How to modify the 360 String pinsetters with the new style of pit curtain to allow light bowling balls to roll under the pit curtain.

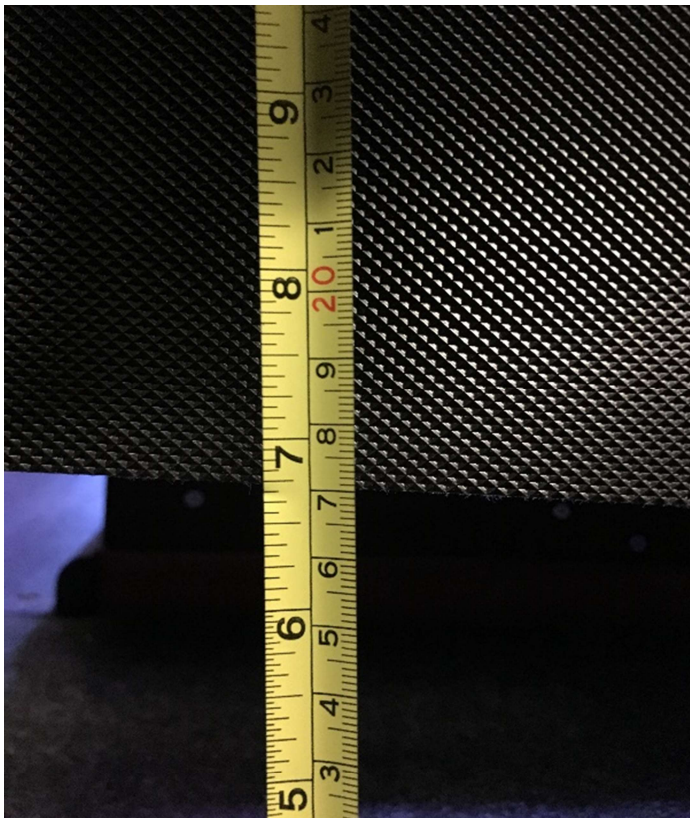
Ensure that the bottom pit board is approximately 6 ¾ inches to the curtain and follow these instructions.

- Loosen the 2 Torx screws on the back side of the pit curtain wooden mounting bracket.
- Remove all the screws that hold the front facing and the 3 screws behind the facing; 1 in each corner and 1 in the middle.
- Remove the side screws first and then hold each end before removing the center screw. If this is not done the entire curtain will fall from the assembly.
- Remove the center screw and lift it flush with the wood frame, then re-install the middle screws first to hold in position.
- Reverse the process to complete modification.
